CITY OF OLYMPIA
BASIC COMMERCIAL DESIGN CRITERIA
Chapter 18.110

Note to the Board: The Basic Commercial Design Criteria are generally intended for commercial buildings that are adjacent to street frontages. Since the building is located over 300’ from the Martin Way street frontage, down a private drive, many of the requirements may not directly apply to this project. Examples include OMC 18.110.020, 18.110.090, 18.110.110, 18.110.130, 18.110.170. The Board may recommend to accept, modify, or remove staff recommendations.

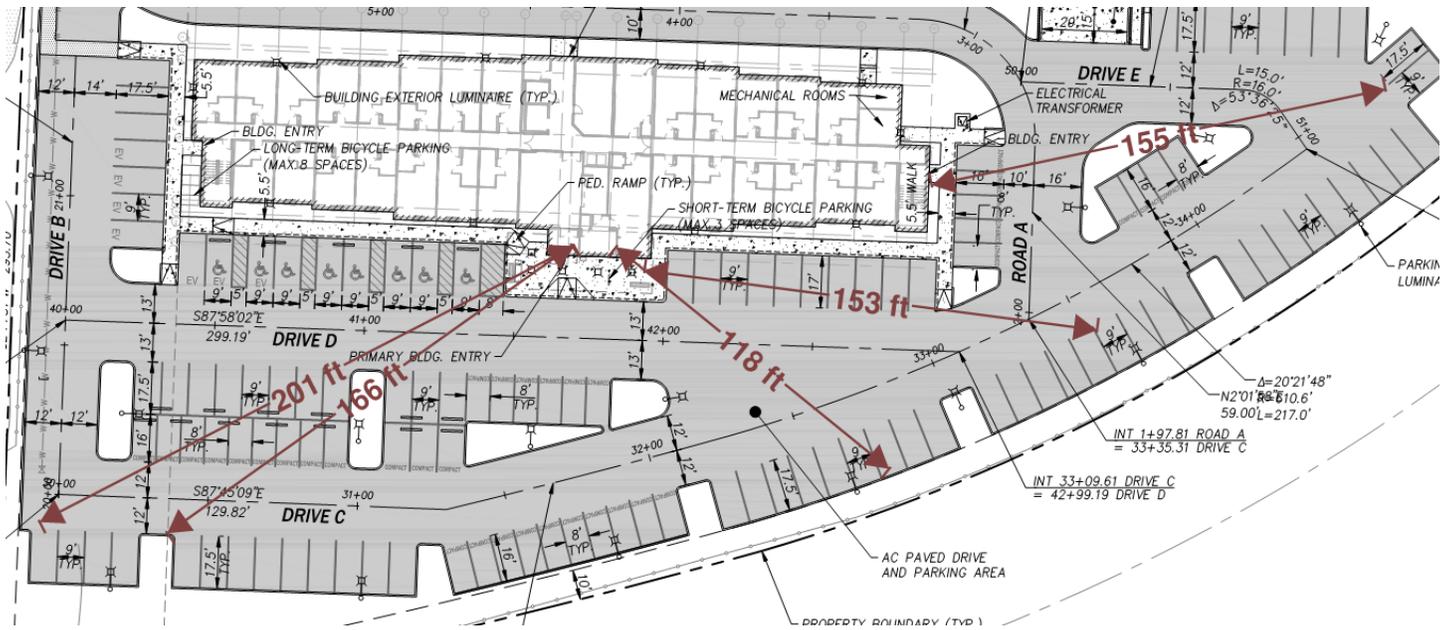
1. Sidewalk adjacent to the drive aisle. The project includes a 5' wide sidewalk and drive aisle that extends from the Martin Way East right-of-way to the entrance of the hotel site, approximately 300' in length. The Chehalis Western Trail abuts this private drive aisle to the immediate west. The retaining wall holding up the CWT varies in height along the sidewalk from 15' to 3' closest to the development site. The sidewalk will be located between a narrow drive aisle and the CWT retaining wall.

The sidewalk should provide access for people of all abilities in a manner that is fully integrated into the project design. The sidewalk should be clearly identified and separated with special treatment such as alternative paving materials, edging, lighting, signage, and plastic bollards or flex posts, etc.

2. Connections from the parking lot to the building. There are currently no parking lot pedestrian crossings that would direct pedestrians through the parking lot to the hotel entrance. The parking lot should have walkways in the form of surface markings or patterns, or distinct hardscape, for example, that help drivers and pedestrians recognize where they need to stop and allow others through, or separate drivers from pedestrians.

3. Connection from the site to the Chehalis Western Trail. The City's Parks Department requires a connection to the CWT as part of the project – the connection is also required by (development) code, OMC 18.38.220, and this Basic Commercial Design Review code, OMC 18.110.030. An entrance to the trail exists on the west side of the trail from Lindsley Lane (Figure X). It makes sense to add a joiner-connection at this same location, albeit on the east side of the trail. Staff believes the applicant should study the area and provide design options, at the detail stage of review, for a connection from the hotel to the trail and/or to the link along Lindsley Lane. Since the Board has a requirement for the connection in this specific code section, the Design Review Board may offer specific design guidance and/or recommendations pertaining to the fence design, type and/or design of a gate, fence materials, and/or lighting that might enable the connection to better relate to sight and building design, and guests and trail users.

- Add safety features to the sidewalk that extends from the Martin Way street frontage to the hotel.
- Provide highly visible, safe pedestrian walkways through the parking lot to the building. The pathways shall be made of alternate materials, colors, and/or raised.
- Provide a direct connection from the project site to the Chehalis Western Trail.

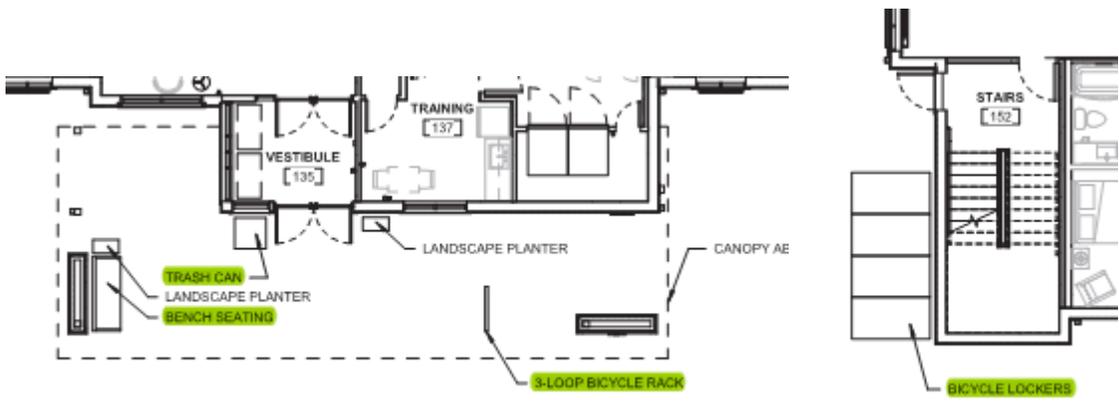
People will typically gather around the main hotel entrance which includes seating, planter boxes, trash receptacles and short-term bicycle racks, as depicted on Sheet 04 (page 7 in the architectural packet). **The Board** may want to consider whether the extent of site amenities meets the intent of this requirement (such as the small landscape planters – should there be more landscaping at the front entrance, to further shape the space, since there is no landscape edging between the building and the sidewalk).

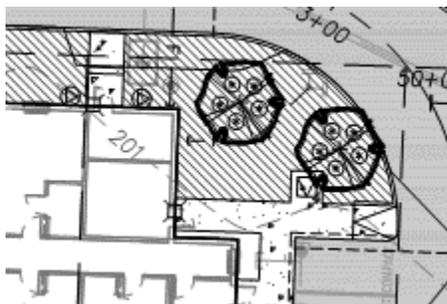
An electric transformer is located in the northeast area of the site near the east building entrance, also close to two internal mechanical rooms. The landscape plan shows kinnikinnick groundcover, viburnum shrubbery, and dogwood trees around the PSE transformer. At the next stage of review the Board should discuss if the vegetation is appropriately located relative to this mechanical equipment.

- All mechanical equipment shall be clearly depicted in the landscape plan and screened so as to not be visible from the public-right-of-way or by residents and guests in the building.
- Wall-mounted equipment shall be screened or painted to match the building.
